SAFETY RECALL CODE 0826 - SIDESTAND LEG FOR 2003 LIGHTNING XB9SL

As recently advised, Buell Motorcycle Company has decided that there is a safety defect with the sidestand legs on certain 2003 XB9SL motorcycles which causes them to have the potential to bend or break without notice, thereby allowing the motorcycle to fall and potentially cause an injury.

**Figure 1. Sidestand Assembly with Sidestand Leg
(Part No. 94218Y)**

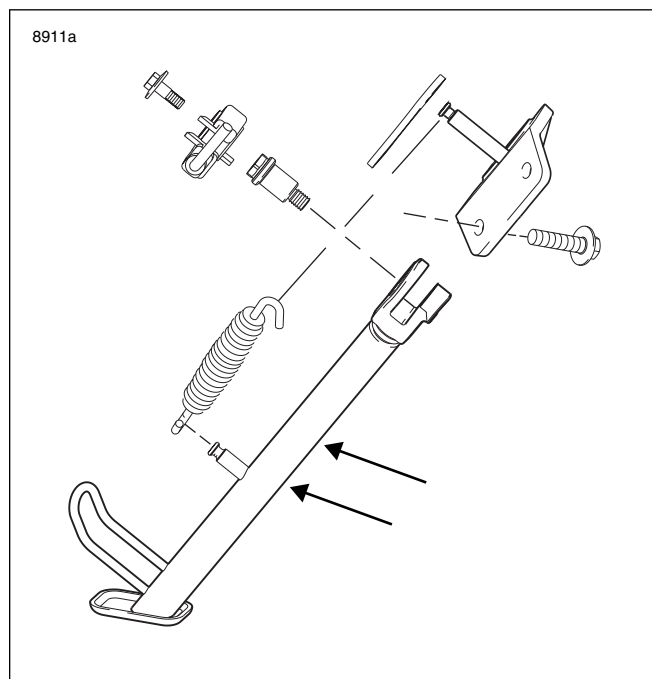
See [Figure 1](#). The correct replacement sidestand for the purpose of this bulletin is Part No. 94218Y.

Figure 2. Sidestand Assembly

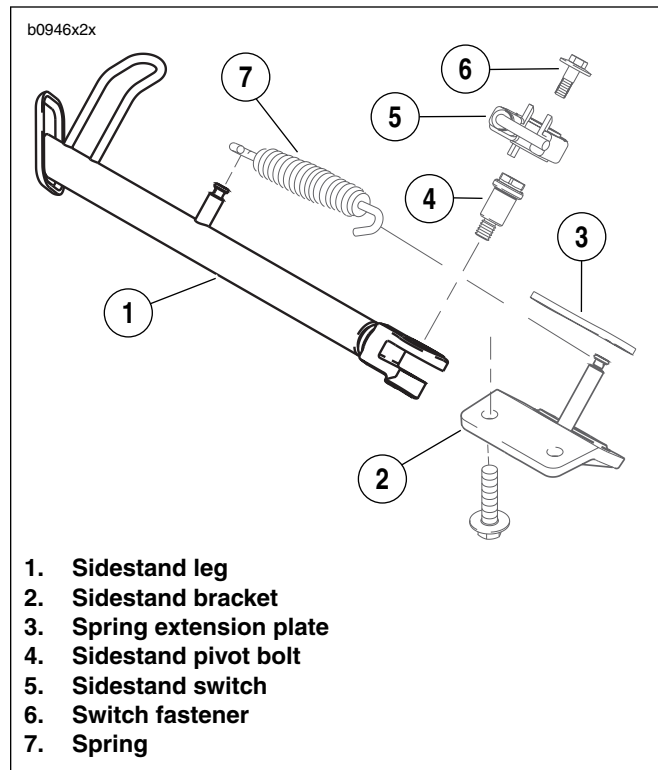
2. See [Figure 2](#). Remove sidestand switch (5).
 - a. Retract sidestand leg (1).
 - b. Remove switch fastener (6).
 - c. Extend sidestand leg.
 - d. Lift sidestand switch and slide to the right away from spring post on sidestand bracket (2) and leave attached to harness.
3. Remove sidestand leg (1).
 - a. Retract sidestand leg.
 - b. Remove sidestand spring (7) and spring extension plate (3) using SNAP-ON SPRING TOOL (Part No. HE-52B).
 - c. Remove sidestand pivot bolt (4).
 - d. Extend sidestand leg and remove.

- c. See [Figure 2](#). Install sidestand leg (1) and sidestand pivot bolt (4) tightening to 18-20 ft-lbs (24-27 Nm).
- d. Retract sidestand leg.
- e. Install spring extension plate (3) and sidestand spring (7) using SNAP-ON SPRING TOOL (Part No. HE-52B).

2. Install sidestand switch (5).
 - a. Extend sidestand leg.
 - b. Install sidestand switch by aligning the lug on the bottom side of the switch with the corresponding hole in the sidestand leg.
 - c. Install the switch fastener (6) tightening to 36-60 in-lbs (4-7 Nm).
3. Apply LOCTITE 272 (Red) to the two fasteners for left side of chin fairing and install. Tighten to 36-48 in-lbs (4-5.4 Nm).

Figure 3. Lubricating Points (Shaded Areas)

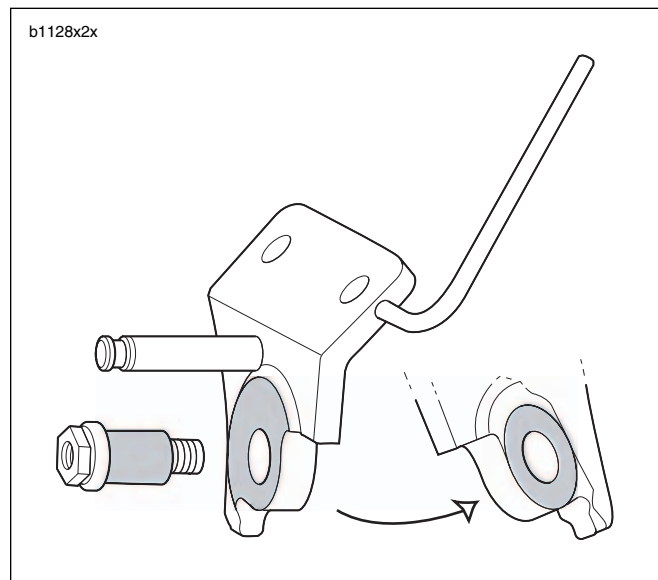
1. Install sidestand leg (1).
 - a. See [Figure 3](#). Lubricate sidestand pivot bolt and mating portions on sidestand bracket with WHEEL BEARING GREASE (Part No. 99855-89).
 - b. See [Figure 4](#). Apply LOCTITE 272 (Red) to threaded area (clevis) of sidestand leg.

Figure 4. Threaded Area for Loctite Application

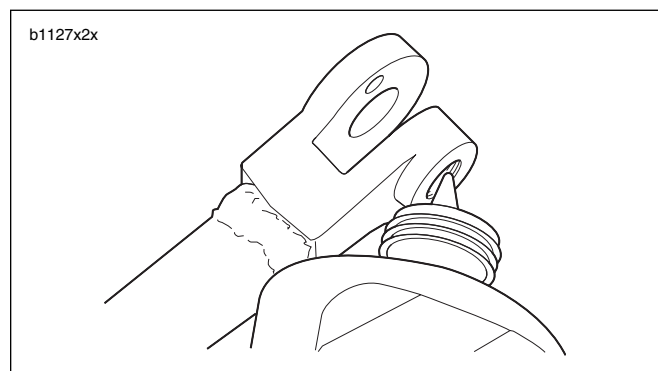
Applying LOCTITE to threaded area of clevis on sidestand leg, instead of threads on the pivot bolt, will eliminate build-up between clevis and sidestand bracket which can interfere with the applied lubricant.
